STAFF REPORT: JULY 9, 2025 MEETING PREPARED BY: E. THACKERY

APPLICATION NUMBER: HDC2025-00291

ADDRESS: 1068 HUBBARD

SCOPE: REPLACE WINDOWS ON THE FIRST AND SECOND FLOORS

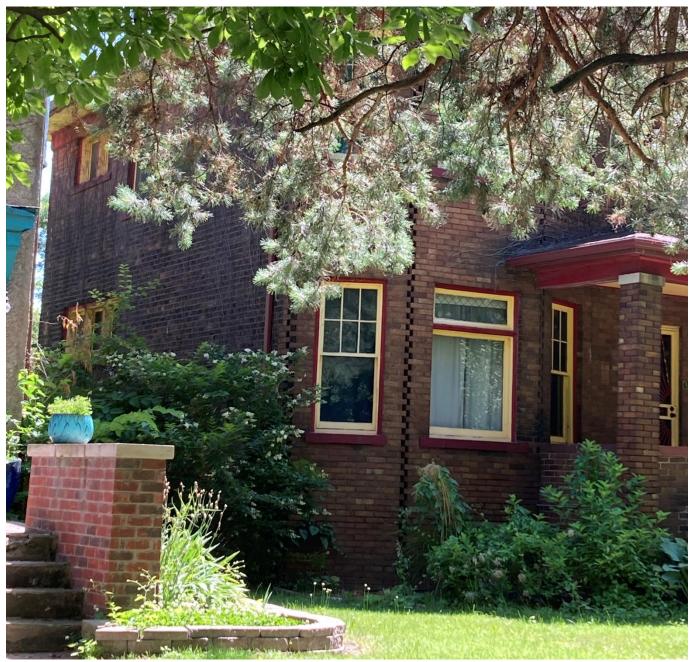
Photo 2, south façade with some of the west (front) façade visible, site visit, 6/23/25, staff. Stained glass is in the oval window close to the front porch, and leaded or stained glass is in the central arched window. On the front of the house, an oval stained glass window is visible centered above the front door and a transom with leaded glass is barely visible behind the square porch column.
